PART VI | COMPARISON DRAWINGS

107 HIGH STREET, LINDFIELD, HAYWARDS HEATH, RH16 2HR

**PART VII | PROPOSED REGULARISATION
OF SCHEME**

PROPOSED REGULARISATION OF SCHEME
SUMMARY

PROPOSED FIRST FLOOR PLAN REV A. 1:100@A3

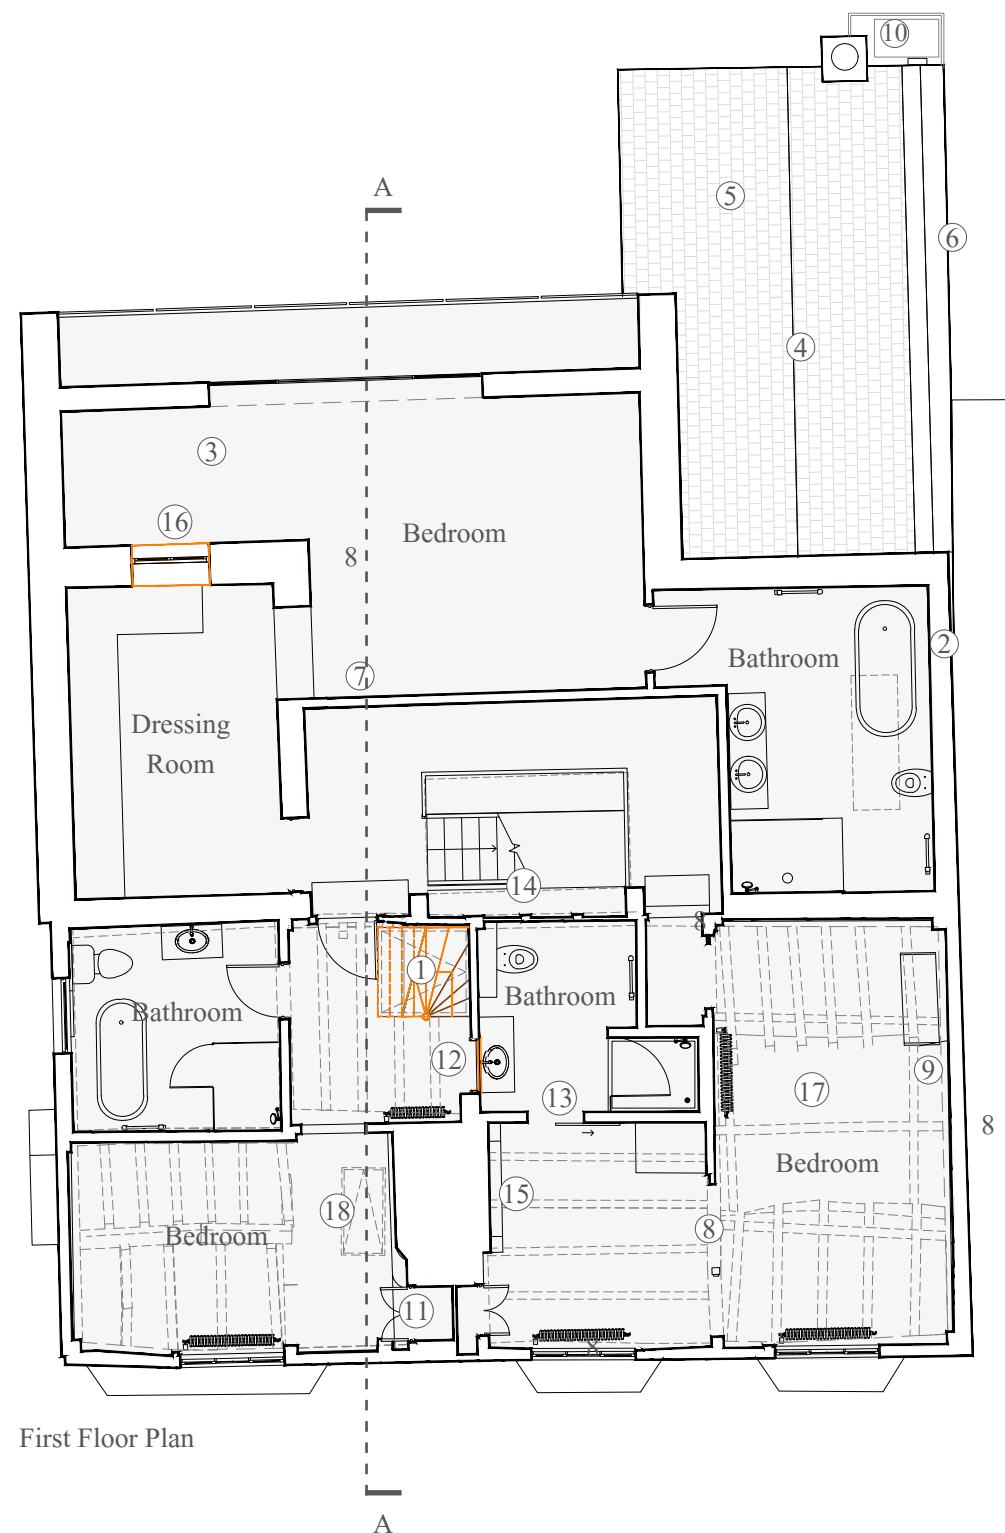
1. Existing joinery and staircase: non-original joinery omitted, staircase to be reinstated in a form close to the original
2. Flat roof extension above bathroom *

3. Rear extension extended - spanning full width, concealing the historic gable - extension to remain, brickwork gable and gothic window to be internally revealed

4. Historic bake house re-constructed following its collapse during strip-out. *
5. Rooflights omitted *
6. Gutter design deviates from approved- parapet wall and secret gutter to enhance rainwater and surface water run off management *

7. Existing door opening blocked up *
8. Plaster infill wall removed, oak frame retained *
9. Existing chimney stack removed *
10. AC AHU louvred timber enclosure - matching timber of new extension *

11. Back to back fitted wardrobes with new joinery installed within the niche*
12. Existing doorway blocked up - opening and door (fixed shut) reinstated. To be exposed on both sides. Vanity unit and sink is freestanding on bathroom side and removable

13. New partition and sliding door to create bathroom*
14. Removal of internal casement windows to box framing of 15th century west wall, openings filled in with timber stud framing, wood wool boards and lime plaster *

15. Re-facing of main chimney breast to ground and first floor rooms in reclaimed brick in hydraulic lime mortar incorporating new hearths *
16. Victorian window and gable wall exposed internally

17. Overlaid seasoned oak flooring to first floor rooms overlaying original floorboards (retained in situ)
18. Attic access hatch *

PROPOSED SECOND FLOOR PLAN REV A. 1:100@A3

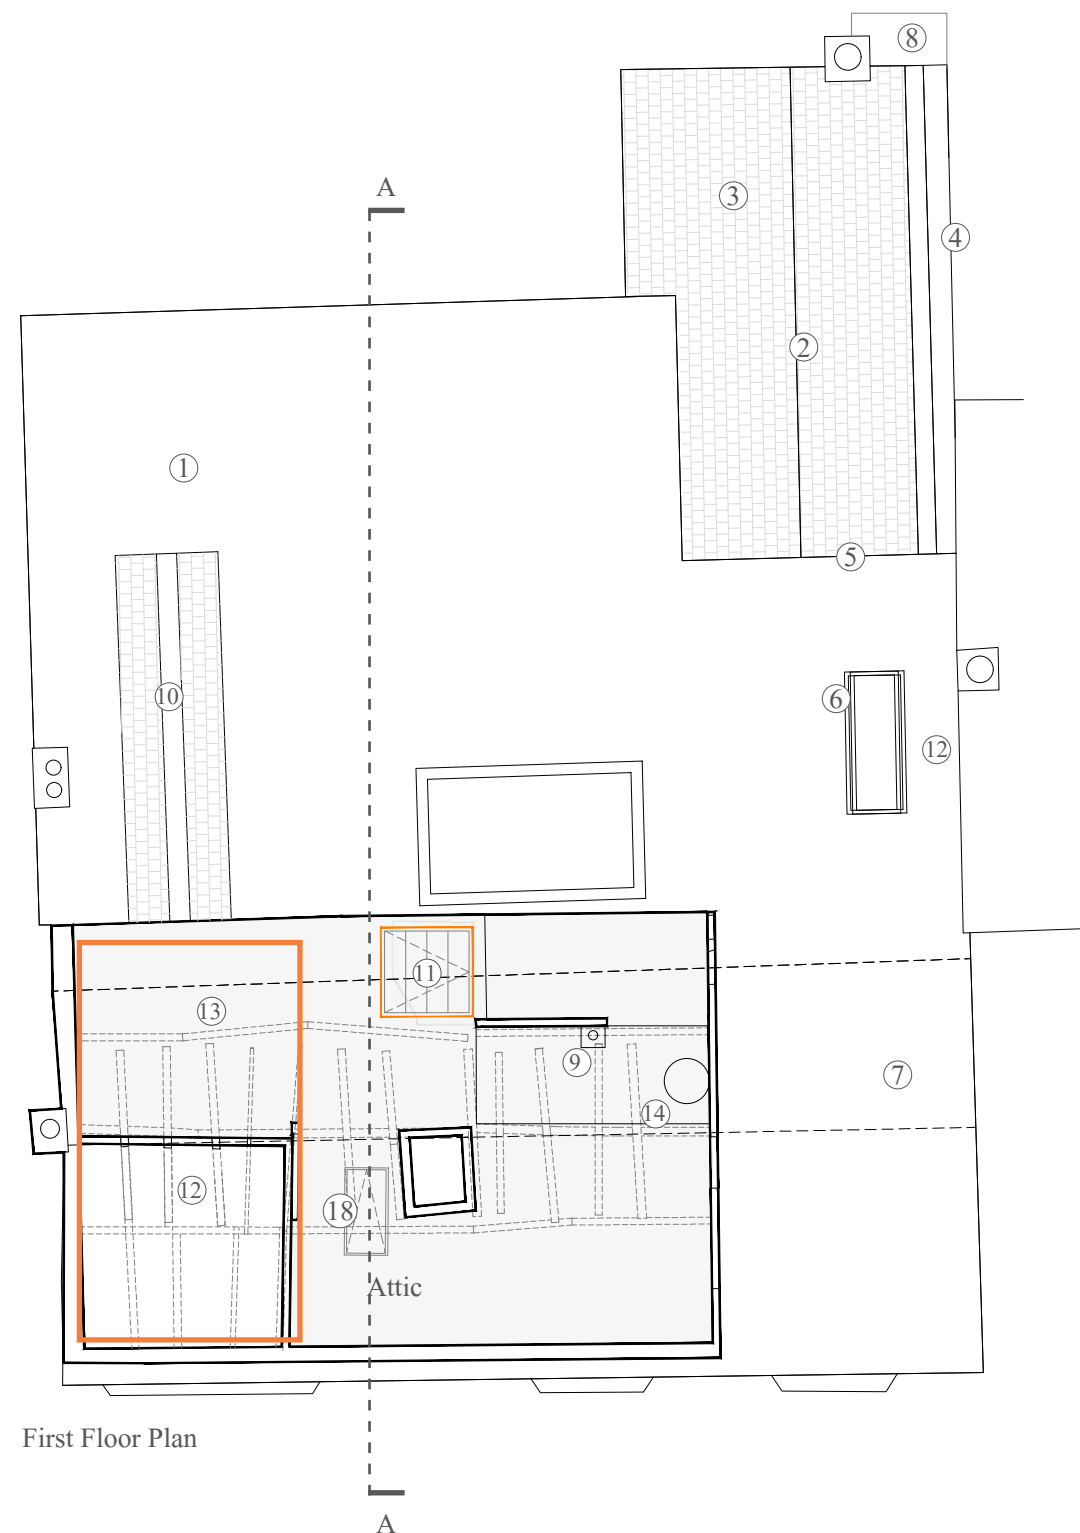
1. Rear extension extended - spanning full width, concealing the historic gable *
2. Historic bake house re-constructed following its collapse during strip-out. *

3. Rooflights omitted *
4. Gutter design deviates from approved- parapet wall and secret gutter to enhance rainwater and surface water run off management *

5. No step between roof planes *
6. Single rooflight instead of two *
7. Existing chimney removed *
8. AC AHU louvred timber enclosure - matching timber of new extension *

9. Boiler and flue installed on rear slope of roof *
10. Historic gable partially visible above new flat roof
11. Staircase linking ground to attic reinstated, access hatch introduced

12. Vaulted ceiling introduced above bedroom *
13. Reinstatement of floorboards in southern part of loft to match historic boards laid loose
14. Water tank on it's own supported base of timbers spreading the weight over the historic rafters below *

15. Attic access hatch *

PROPOSED ROOF PLAN. 1:100@A3

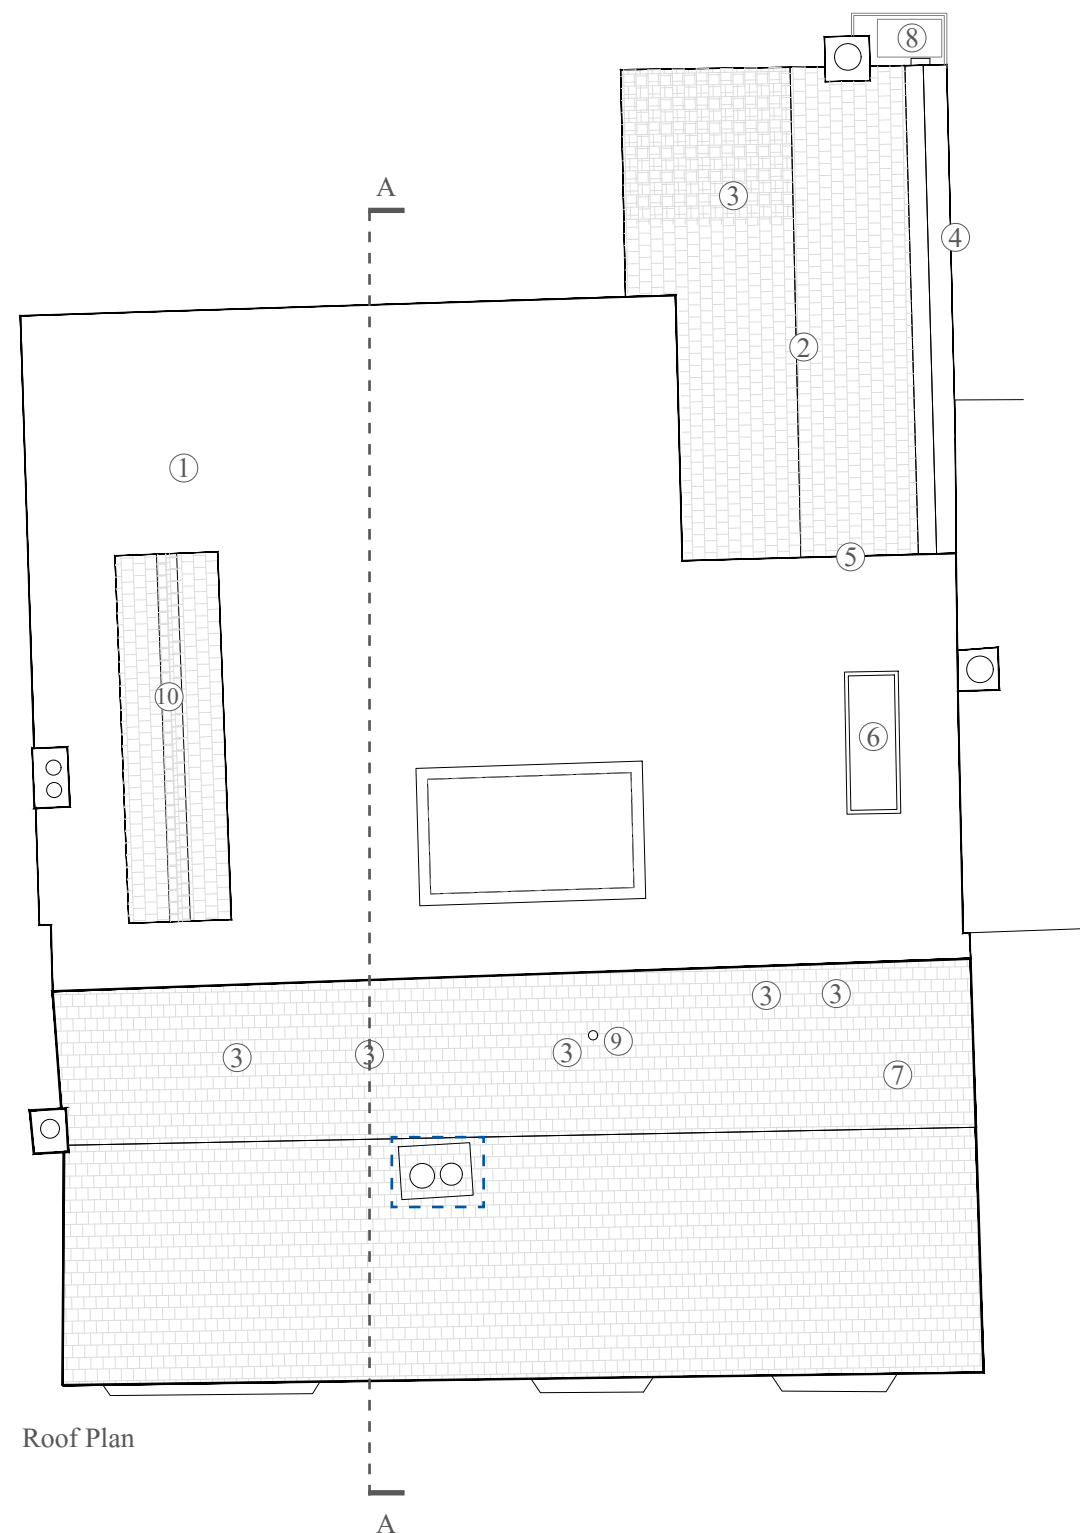
1. Rear extension extended - spanning full width, concealing the historic gable *
2. Historic bake house re-constructed following its collapse during strip-out *
3. Rooflights omitted *
4. Gutter design deviates from approved- parapet wall and secret gutter *
5. No step between roof planes *
6. Single flat rooflight instead of two pitched roof windows*
7. Existing chimney removed *
8. AC AHU louvred timber enclosure - matching timber of new extension *
9. Boiler flue on rear slope roof *
10. Historic gable partially visible above new flat roof

PROPOSED EAST ELEVATION. 1:50@A3

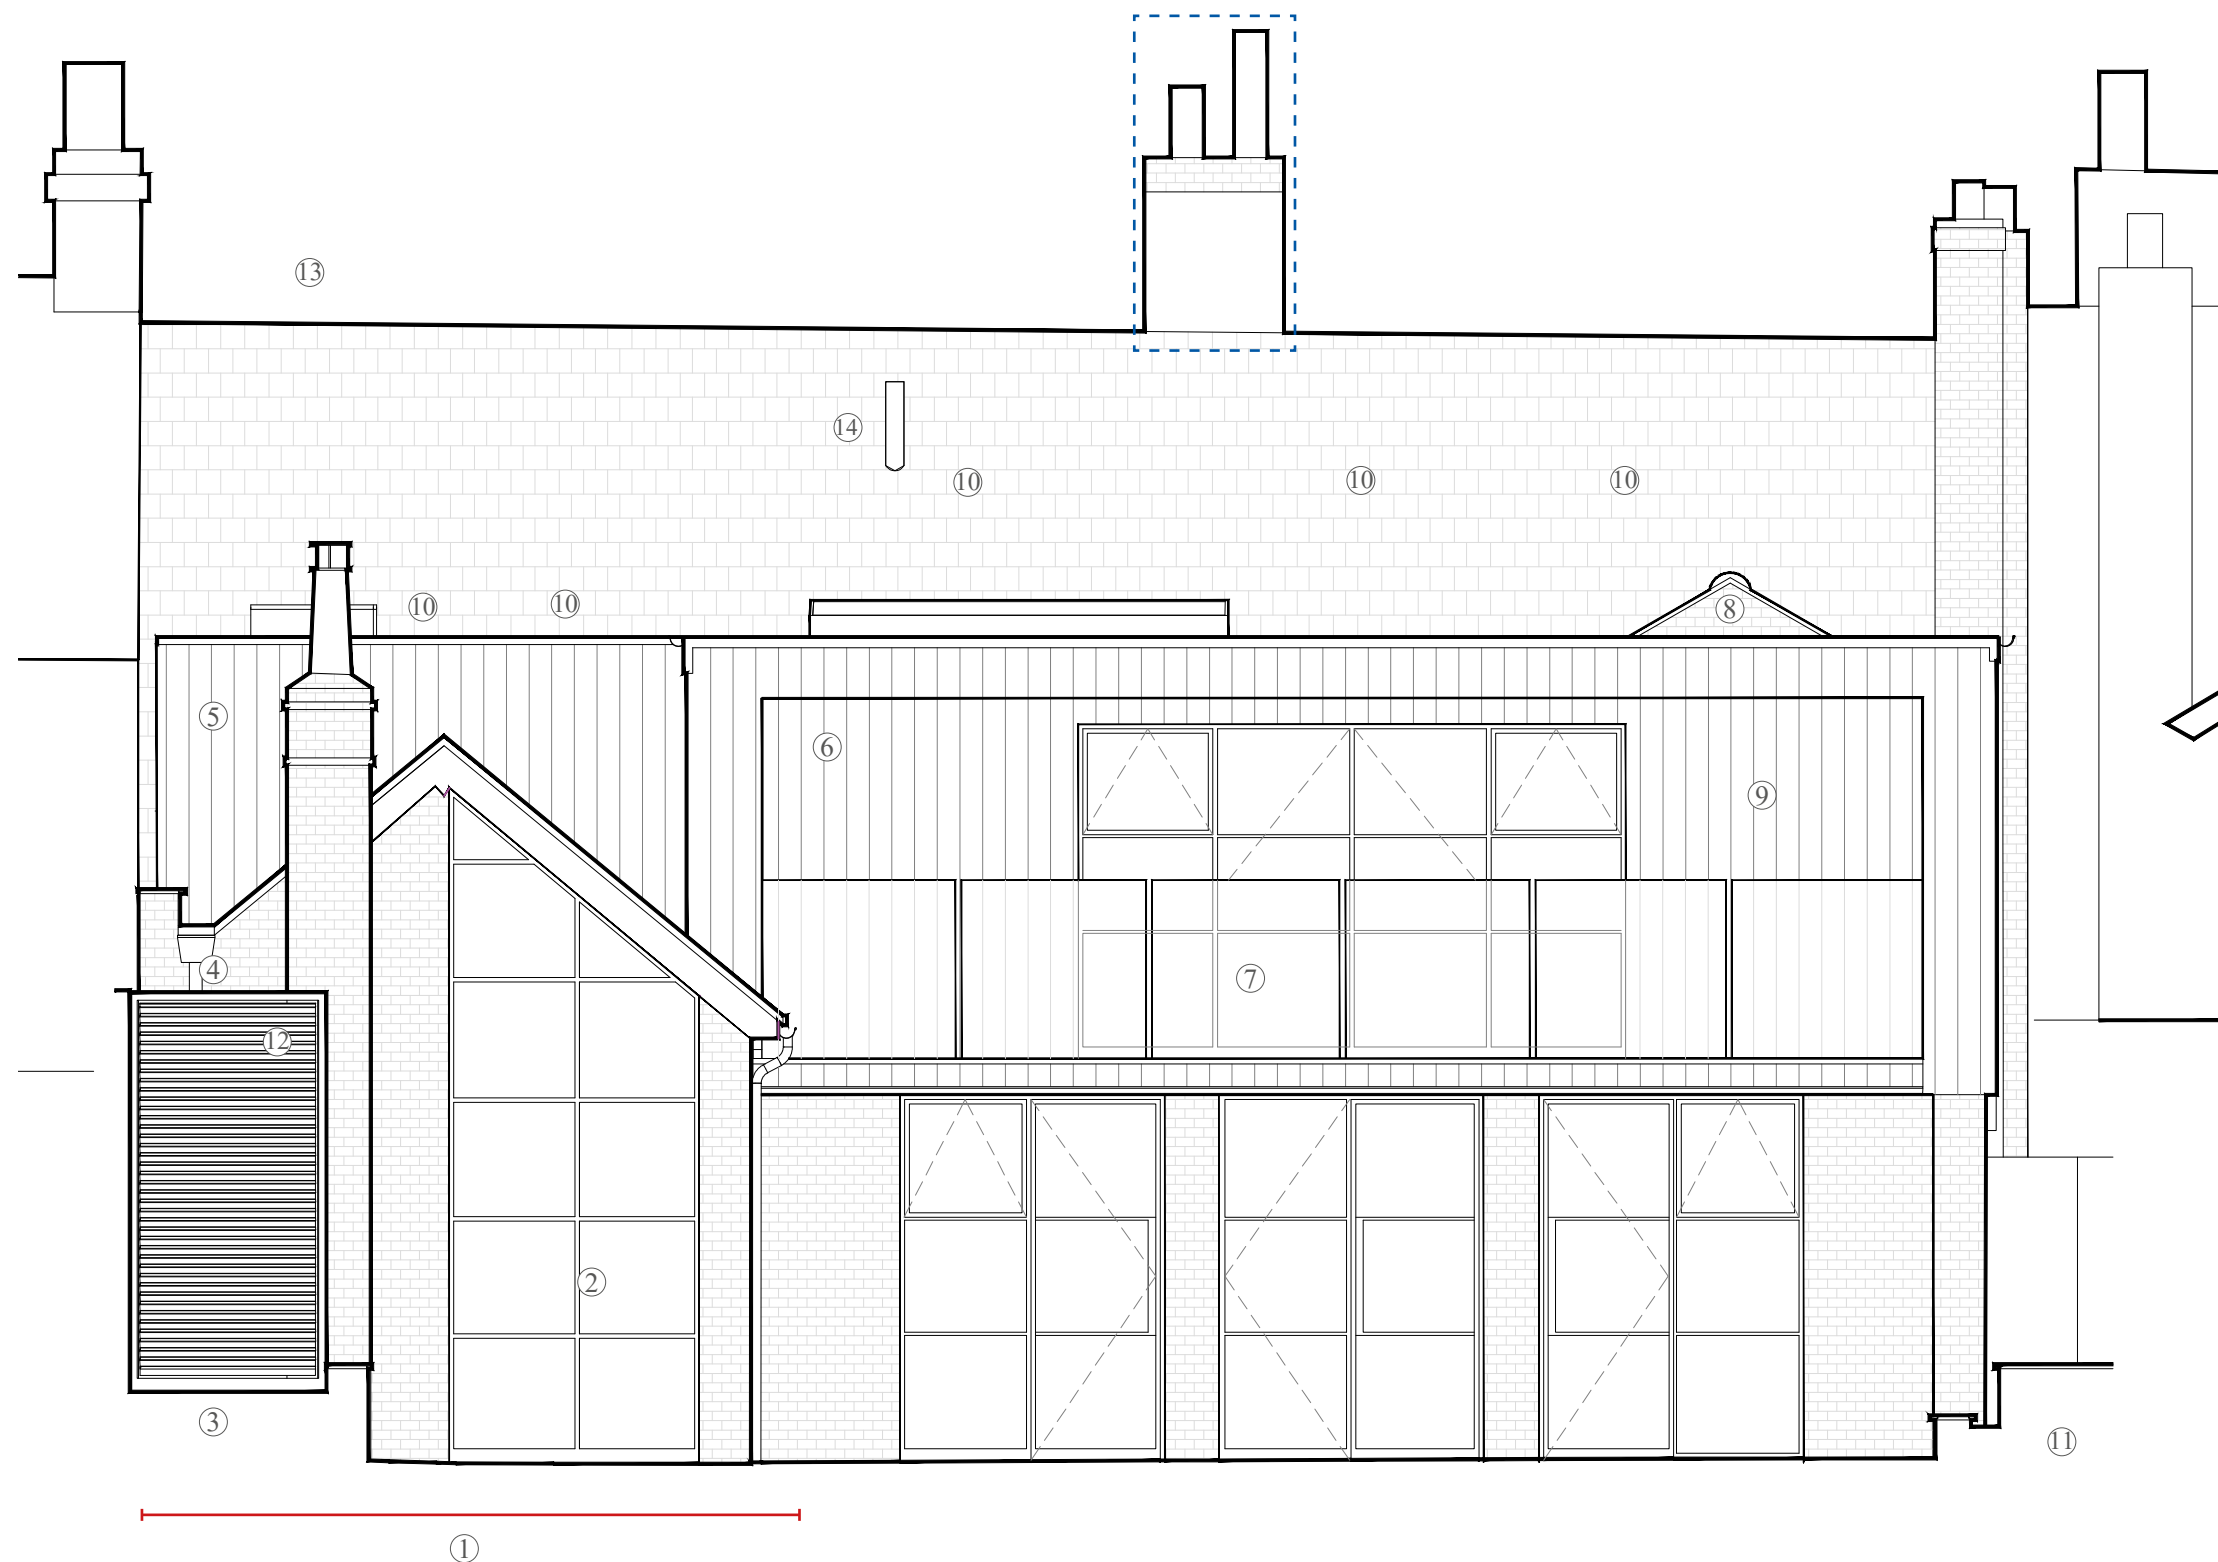
1. Different door ornamentations introduced *
2. Side lamps omitted *
3. Vent added *
4. Existing chimney removed *
